Bay Hill Development Transportation Assessment Report Review

Timaru District Council

Prepared for: Timaru District Council
Job Number: TDC-J008
Prepared by: Ross Rutherford, Principal Transportation Planner
Reviewed by: Paul Durdin, Director

Abley Transportation Consultants have been commissioned by Timaru District Council to peer review the transport aspects of the resource consent application for a mixed use development of the site of the Hydro Grand Hotel, 10 The Bay Hill, Timaru. Transport aspects of the proposed activity are described in a Transportation Assessment Report (TAR) prepared by TDG and further information provided subsequent to a Request for Further Information (RFI).

Figure 3.1 TAR Assessment of Total Parking Demand

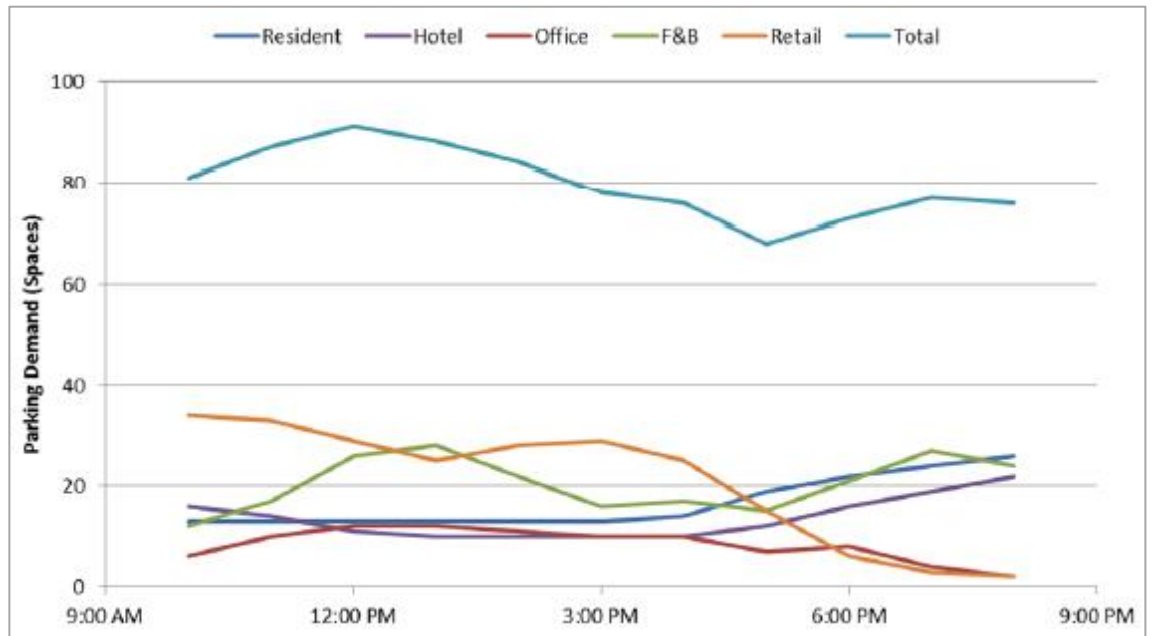
Note: The key included in Figure 11 of the TAR is incorrect. The orange colour should be “office” and the red colour should be “retail”.

Although the use of shared parking demand model is largely supported, it is considered that the estimation of parking occurring outside of the parking building has been underestimated, for the following reasons:

The response to RFI shows a large drop in the food and beverage and retail parking demand between Figure 4.1 (TAR) and Figure 4.2 (response to RFI). The former gives a combined peak parking demand for these activities of 40 spaces, while the latter produces a combined peak demand of approximately 27 spaces (reduction of 13 spaces).

Figure 3.2
Response to RFI
Assessment of
Total Parking
Demand

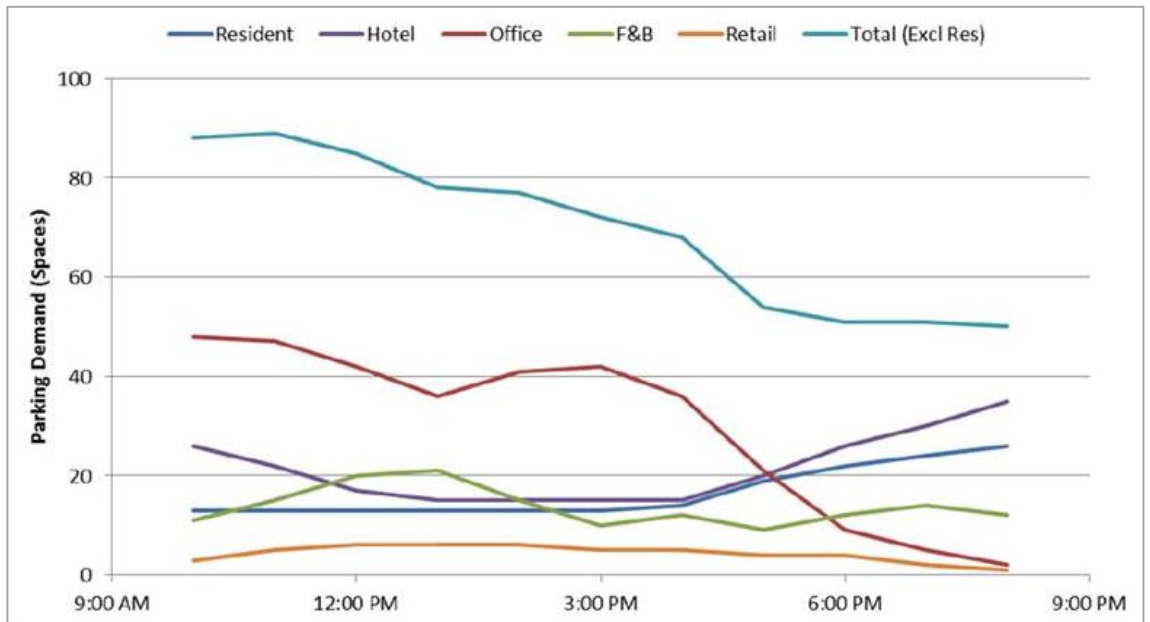
- Peak parking demand generated by the overall activities is estimated to occur at 11am, when:
 - Parking demand for the office is approximately 47 spaces;
 - Parking demand for the hotel is approximately 21 spaces;
 - Parking demand for food and beverage is approximately 17 spaces; and
 - Parking demand for retail is approximately 5 spaces.

Based on the numbers above, the minimum reliance on parking outside the parking building would be 36 spaces comprising 14 long-stay spaces for office employees, and 22 spaces for food and beverage and retail staff and customers (generally short-stay). Actual reliance on off-site parking could be higher, as the interpretation of the model by TDG appears to assume that parking will occur on-site in preference to off-site, and occupancy will be 100% on-site when overall demand equals or exceeds supply.

Initially, it was presumed that the parking model was sufficiently sophisticated to allocated an increasing portion of food and beverage and retail activities trade to office workers, as the scale of the office component grows. However, upon examination of the parking model provided by the Applicant, it shows that no such interrelationship exists. **Whilst a reduction in parking demand for food and beverage and retail activities with increasing office space is likely to hold true to a certain extent, in this instance, the entire parking demand reduction for food and beverage and retail activities (13 spaces at 1pm) is offset by a corresponding increase in parking demand of 13 spaces for the office activity during the same period. It is difficult to reconcile how an increase in office GFA of 954m² with no change in GFA to the food and beverage or retail activities can result in no net parking demand change at 1pm. This is suggestive of an error with the model.**

Figure 3.3
Reviewer
calculated parking
demands using
Parking Model

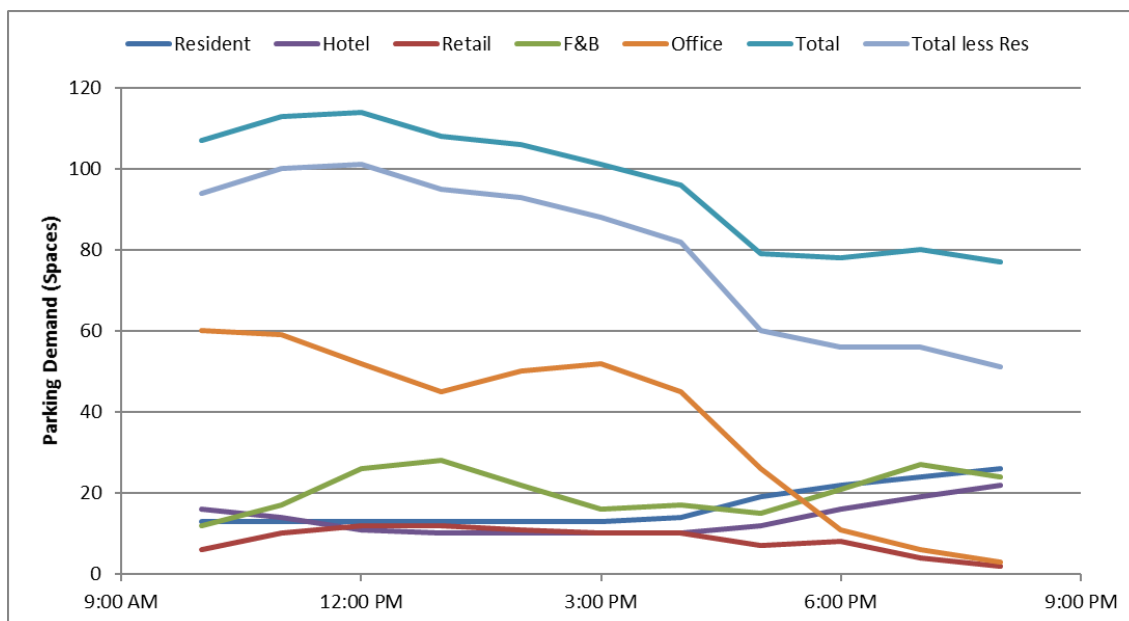
This shows a parking demand of 40 vehicles for the food and beverage and retail activities at 1pm, and a much-increased demand for office parking compared to that provided in the response to RFI.

NZTA Research Report 453 Trips and parking related to land use, November 2011 gives average parking rates of 3.6/100m² GFA for small shopping centres, and 8.0/100m² GFA for drive in fast food restaurants in Table 8.10. These rates would generate a peak parking demand of 47 spaces (15 + 32). This is considerably more than the peak demand of 27 spaces estimated in the response to RFI, but largely consistent with the estimated in the TAR of 40 spaces. On this basis, a peak parking demand for the food and beverage and retail activities is expected to be more in the order of 40 spaces and not the 27 spaces estimated in the response to RFI.
